4866

LVCCLD Library at Bonanza S. 28th

CITY OF LAS VEGAS		DATE:
INTER-OFFICE MEMORANDUM		April 12, 2017
TO: Land Development Services Department of Building & Safety		FROM: Albert Sung, P.E. Flood Control Project Engineer Department of Public Works
SUBJECT:	COPIES TO:	
Drainage Study for:	T.Y. Lin International	
LVCCLD Library at Bonanza & 28th	LVCC Library District	
Cross Streets:	SEC of Bonanza Road & 28 th Street	Bart Anderson, P.E., DevCo
File Number:	F:\Depot\DSMemos\DS4866B.doc	CCRFC
Parcel Number:	139-36-110-031 & 139-36-110-032	
Zoning Action:	GPA-67913; ZON-67914 & SDR-67915	
FEMA Flood Zone	YES	NO X
Proposed Storm Drain	YES	NO X

EX1

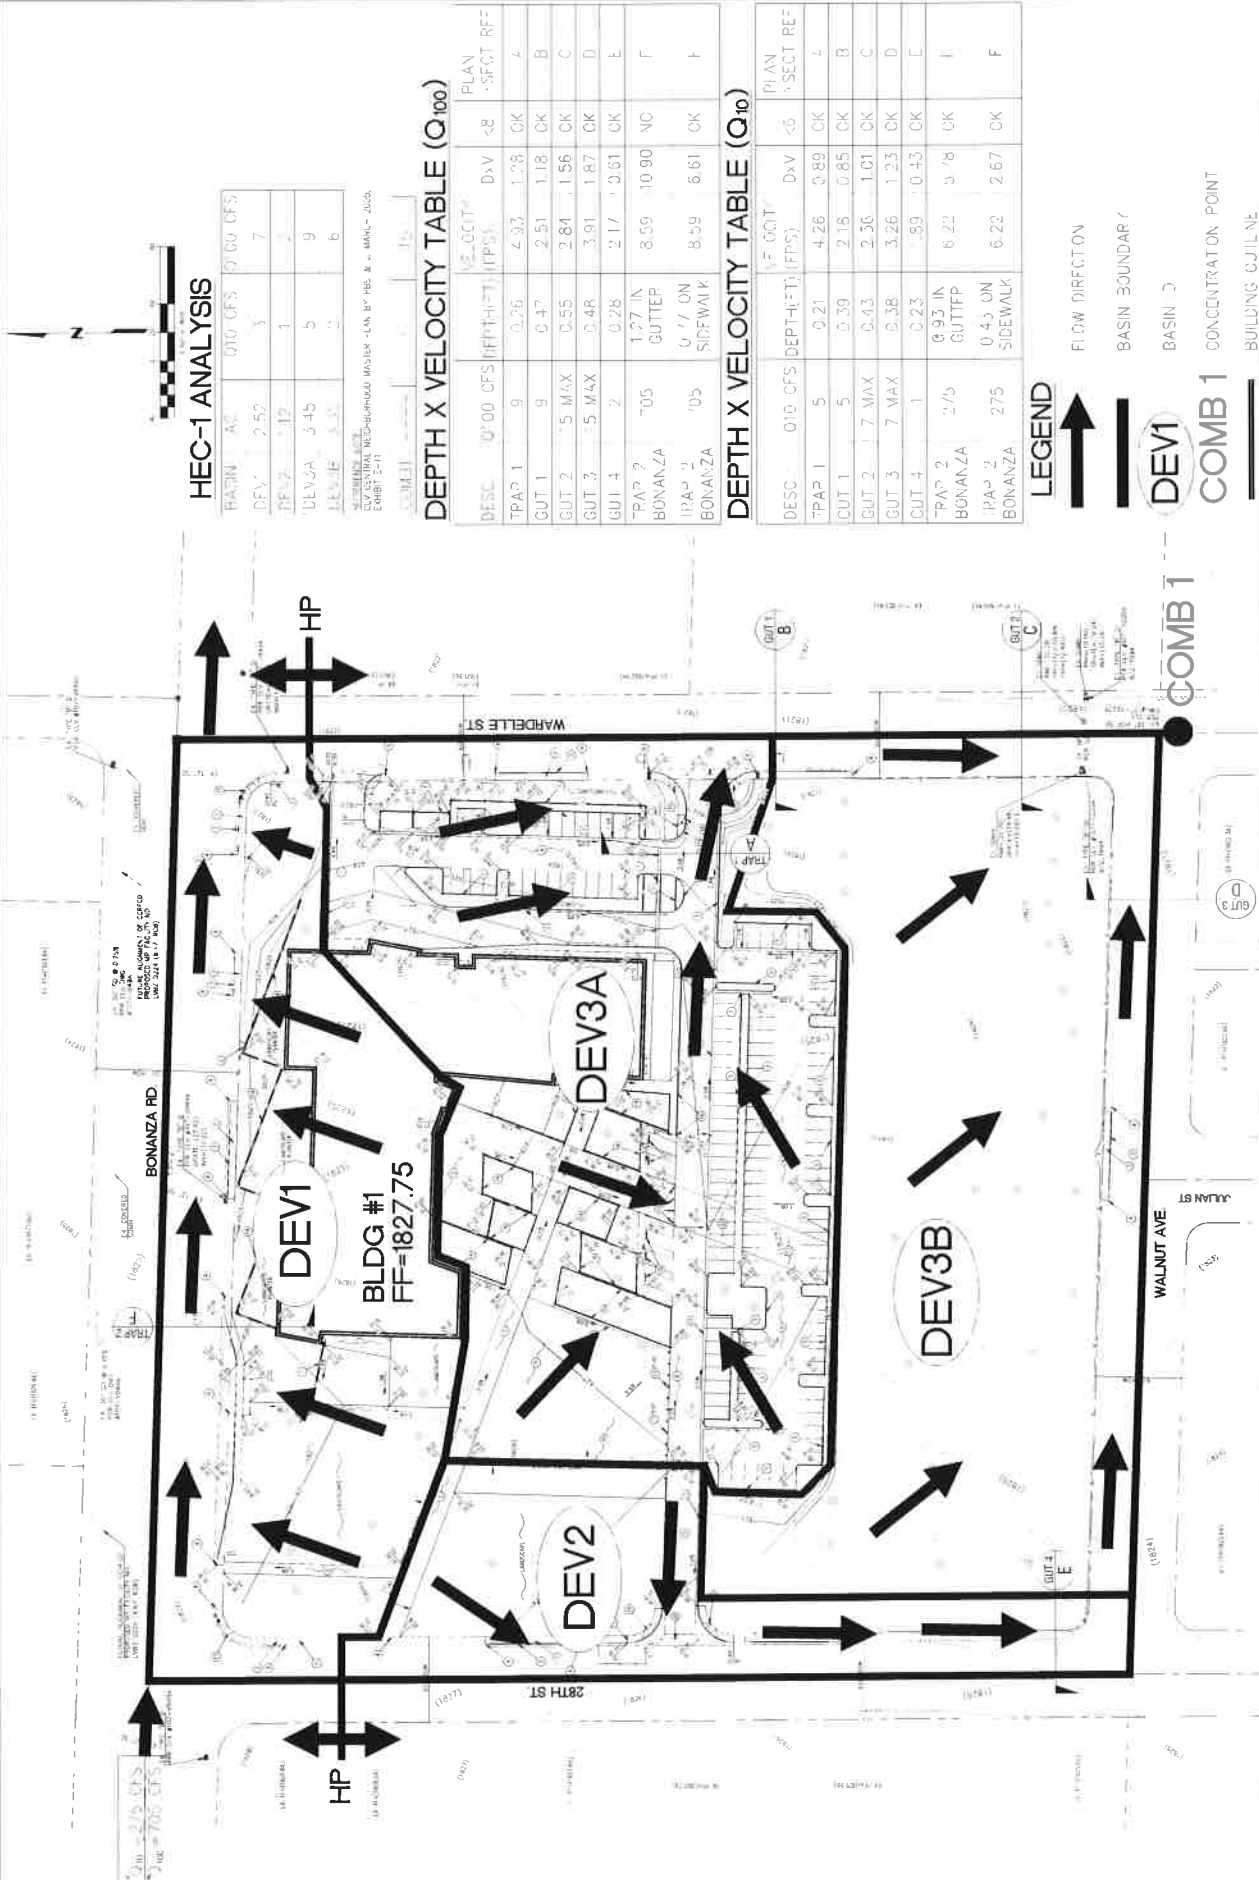
- On **Existing Basin Map (EX1)** and **Developed Basin Map (DEV1)**, provide a street hydraulics summary table such as Q_{10} , Q_{100} , V_{10} , V_{100} and DV parameters for all perimeter streets in the next submittal.

GRADING PLAN 2

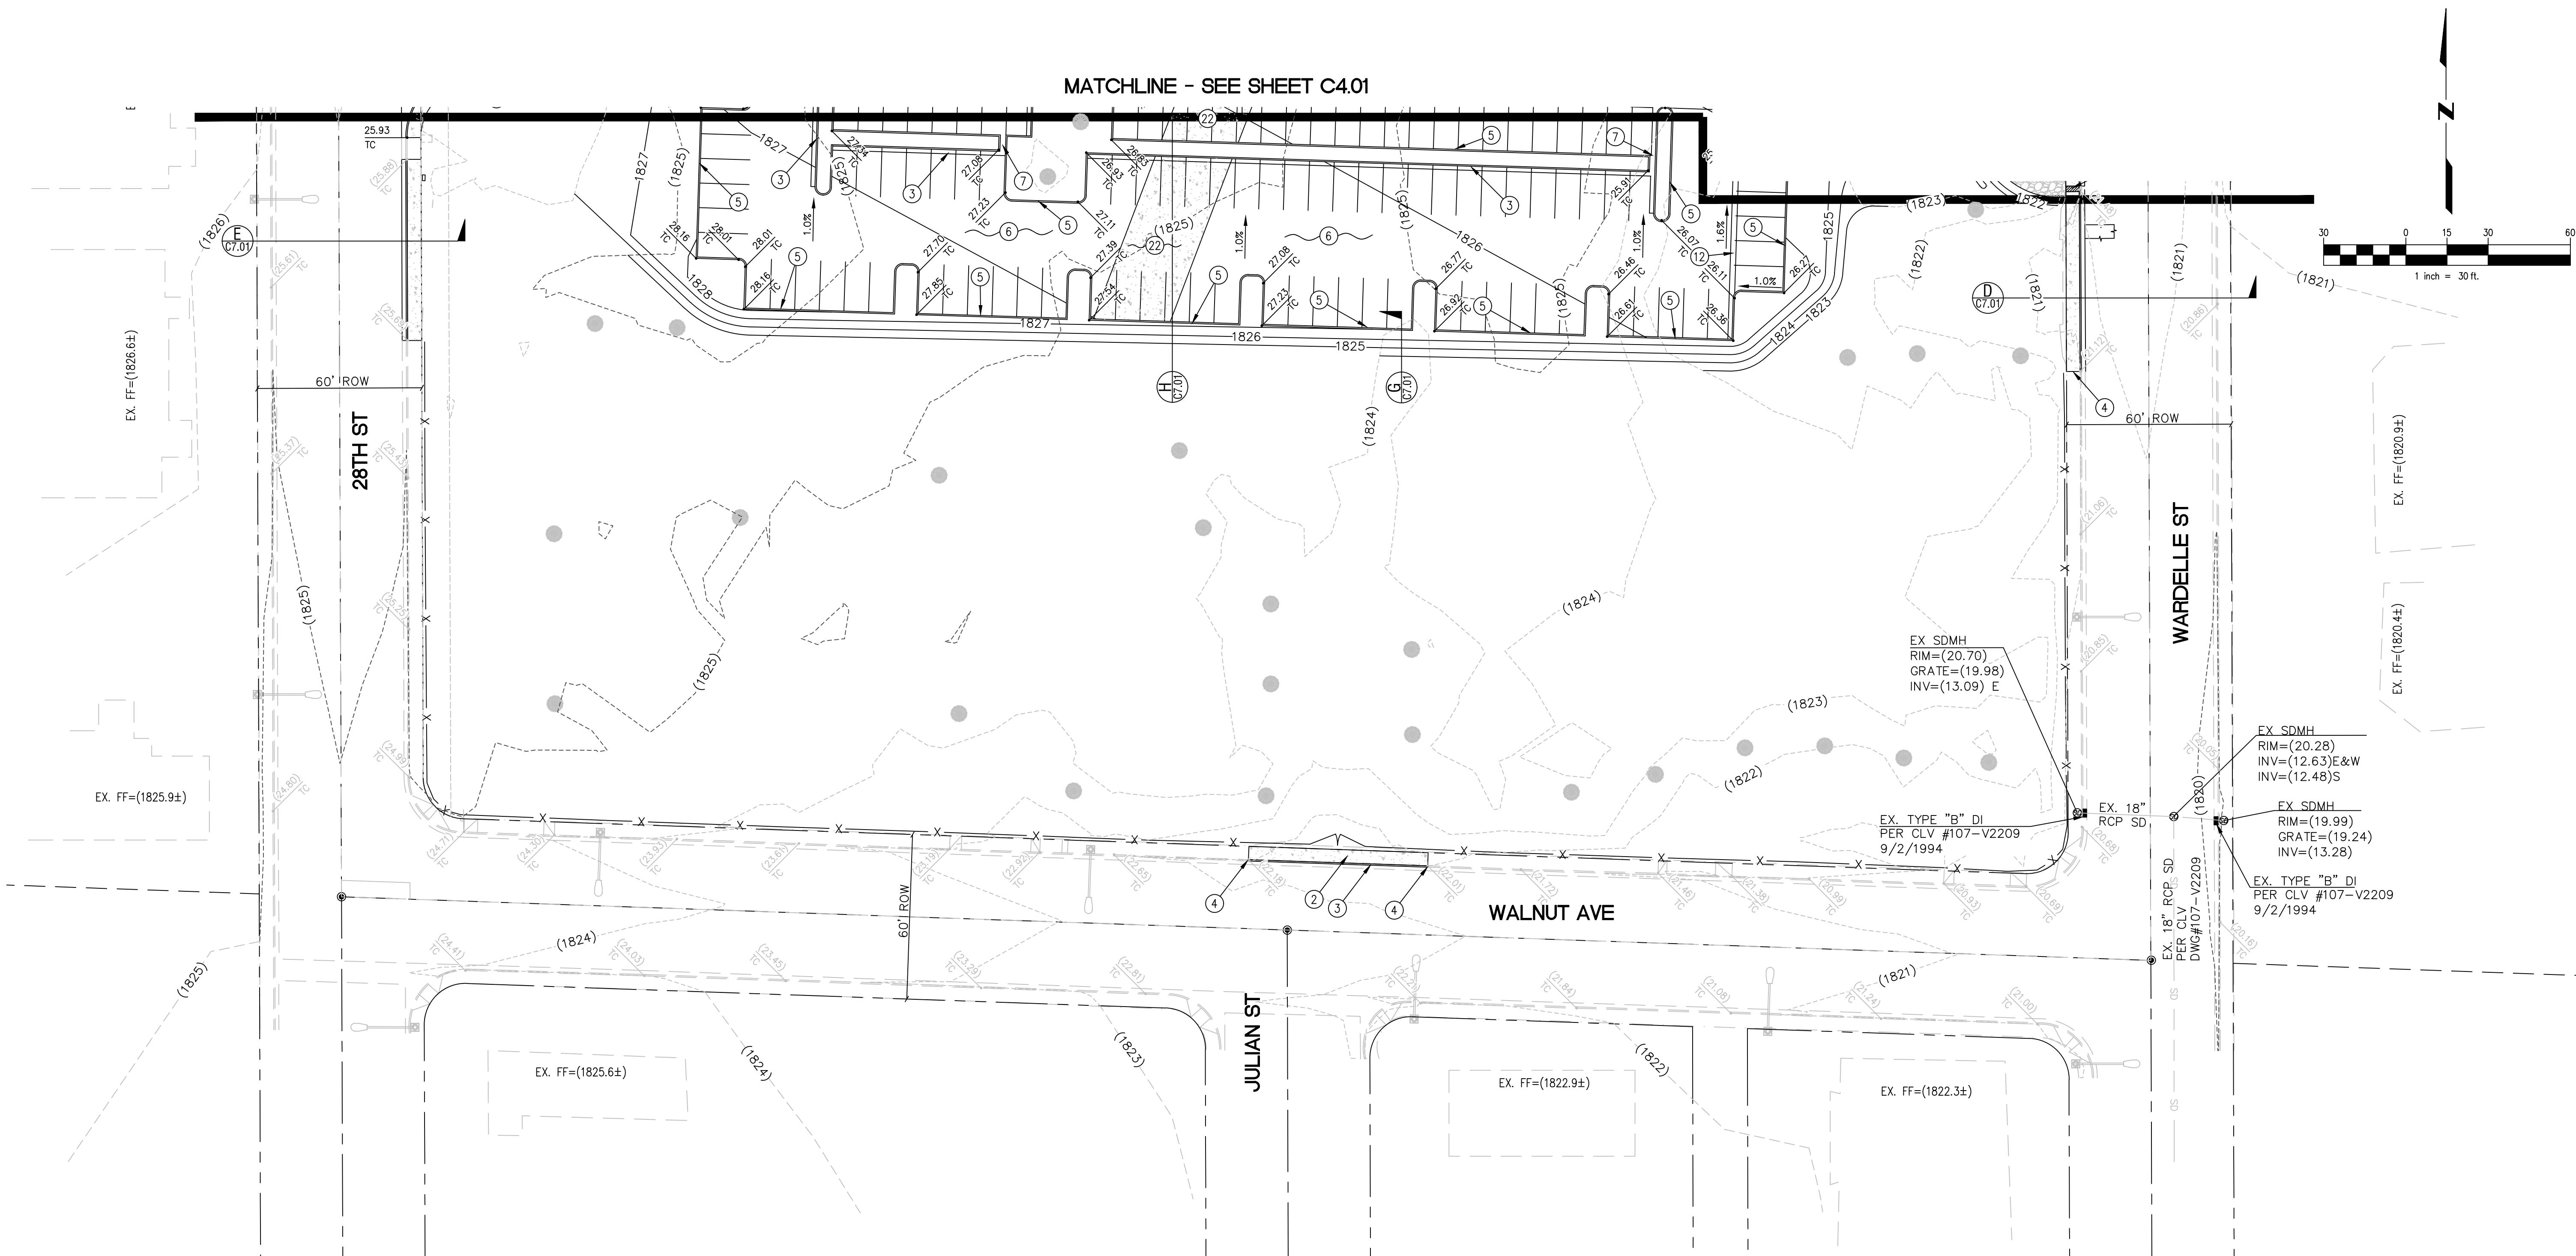
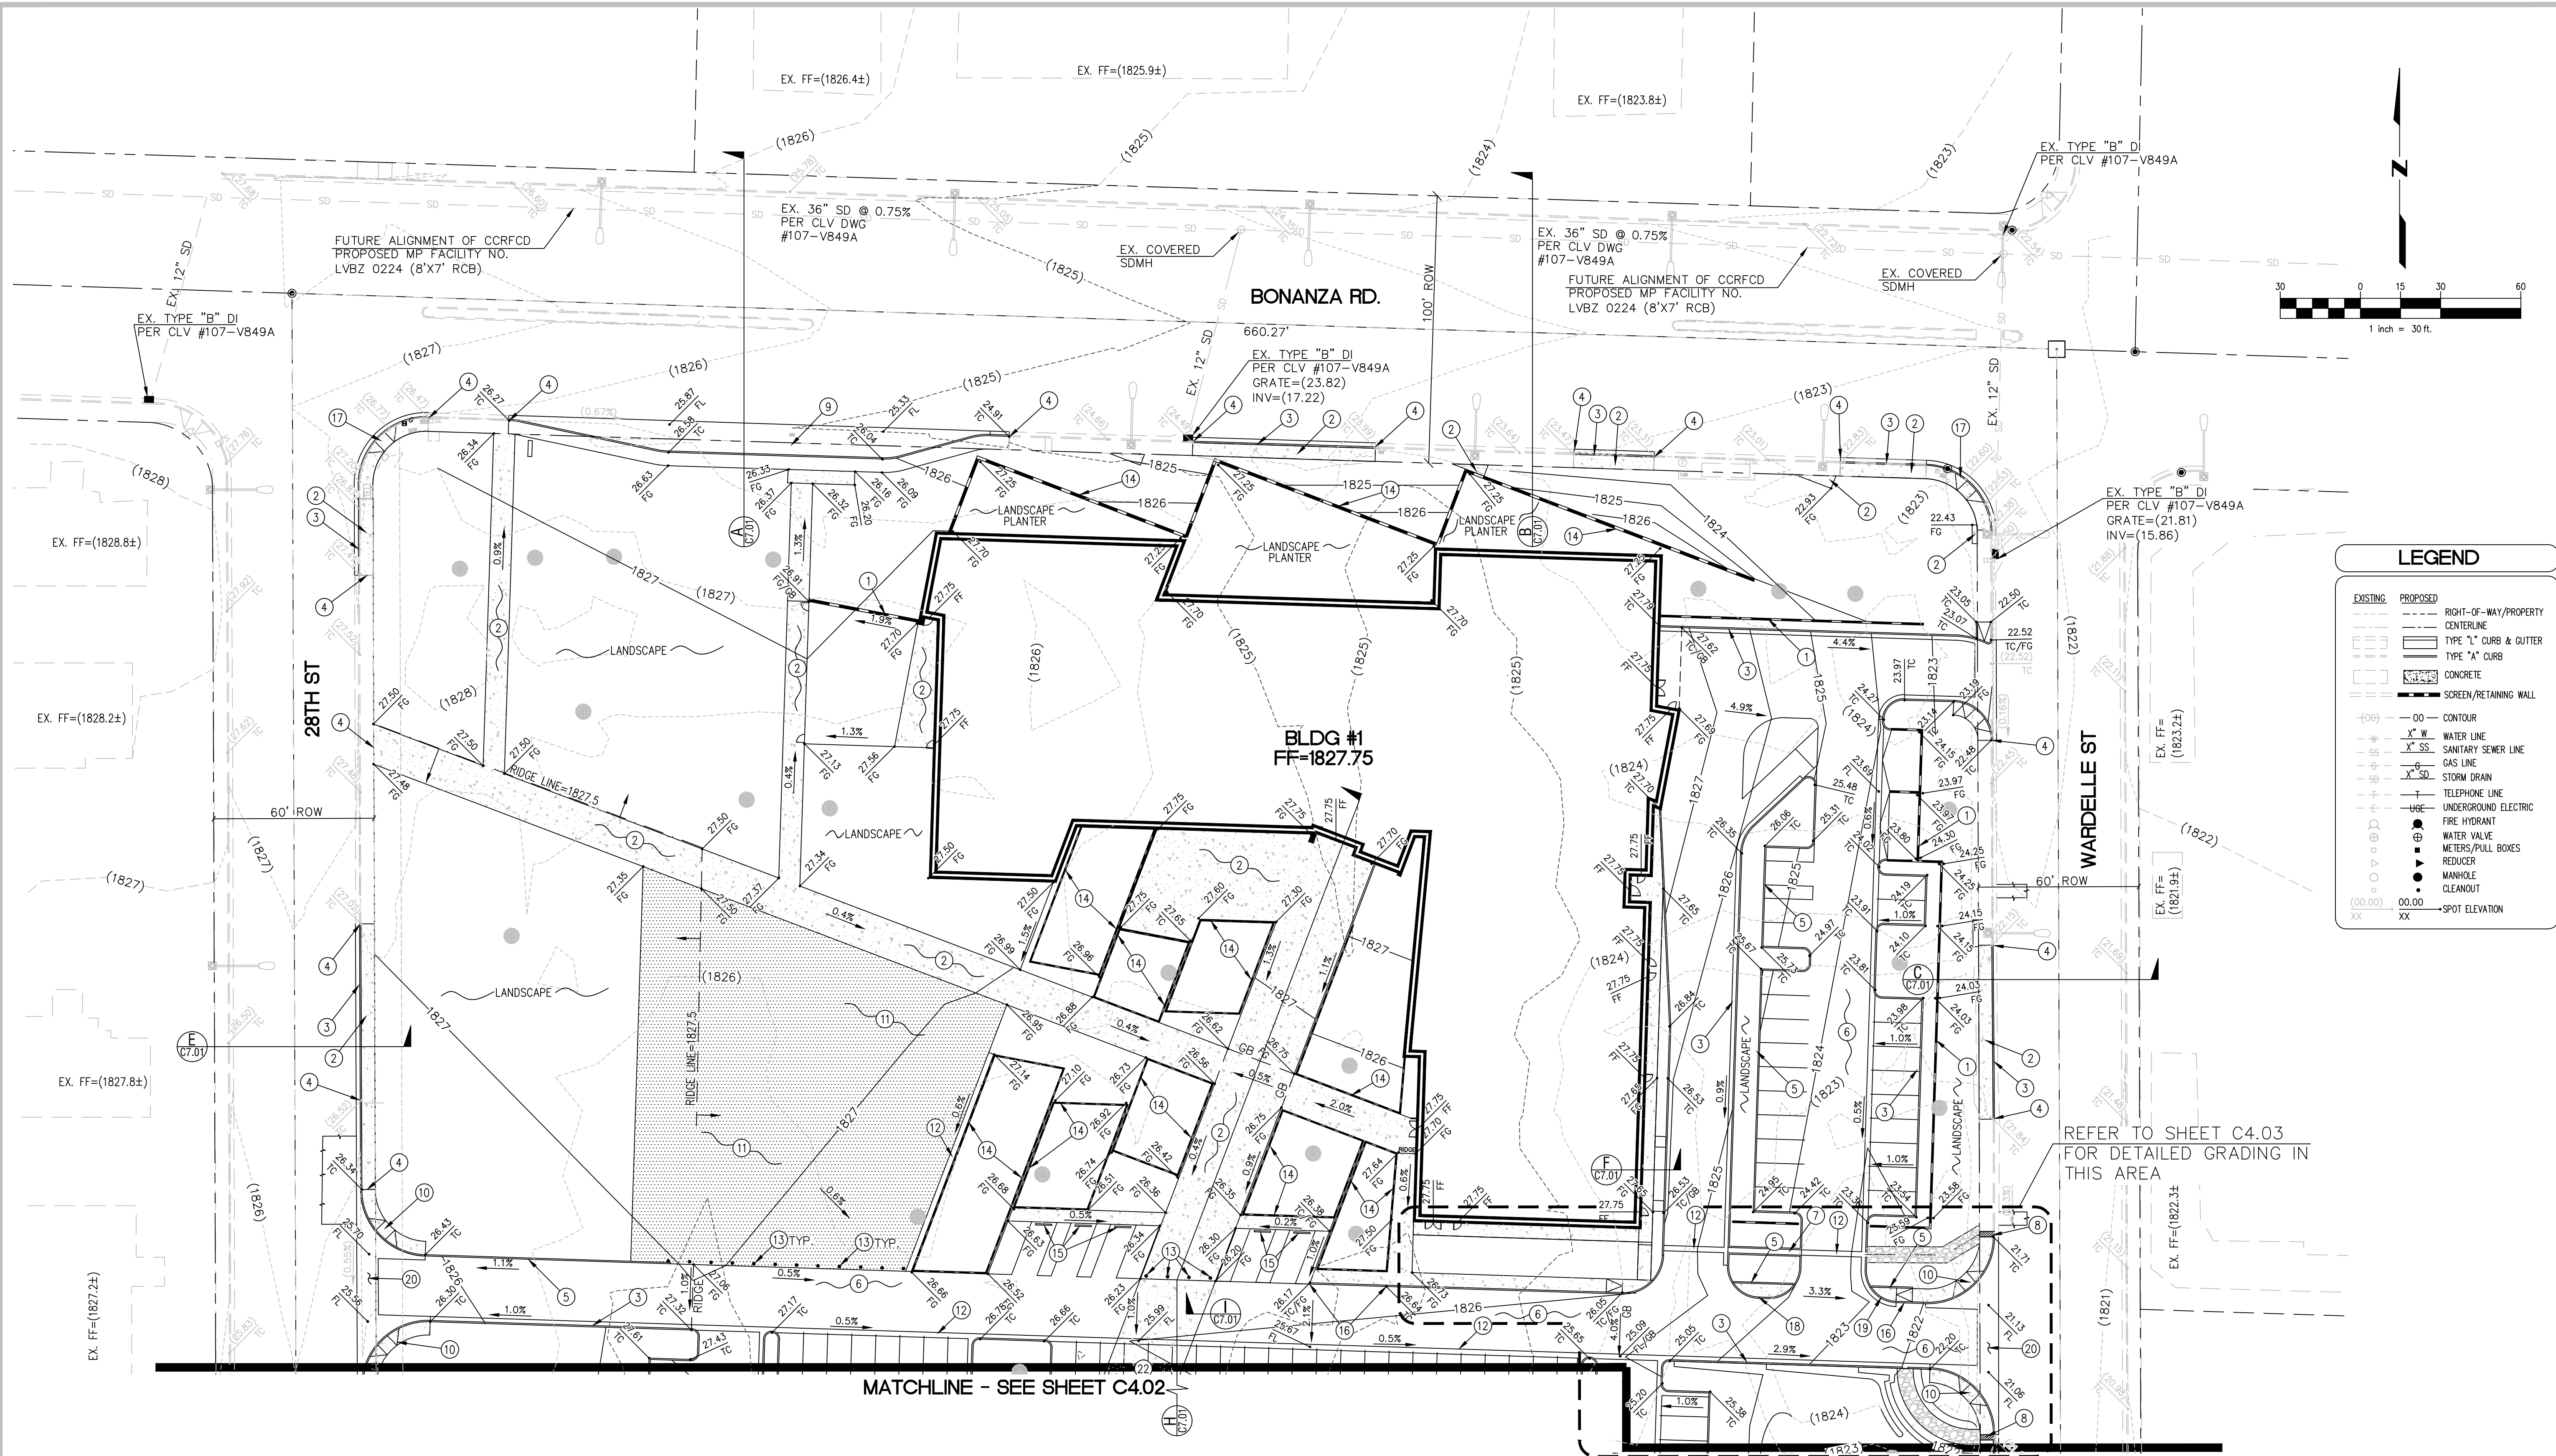
It appears that there are three enclosed space adjacent to the north of the proposed new building. The spaces are closed by the building wall and some planter walls without any points for discharge. Address and resolve in the next submittal.

Provide a note on all grading plans: Property Owner is responsible to maintain the best management practices such as but not limited to the removal of accumulated sediment and debris and care of the vegetation.

Per a meeting between Albert Sung, P.E. and TYLI on March 15th, 2017, TYLI will clarify that the areas in question are not enclosed spaces and are in fact planter areas. Please refer to the attached revised grading plans.

TYLI will comply, refer to attached revised grading plans.

PROPERTY OWNER IS RESPONSIBLE TO MAINTAIN THE BEST MANAGEMENT PRACTICES SUCH AS BUT NOT LIMITED TO THE REMOVAL OF ACCUMULATED SEDIMENT AND DEBRIS AND CARE OF THE VEGETATION.
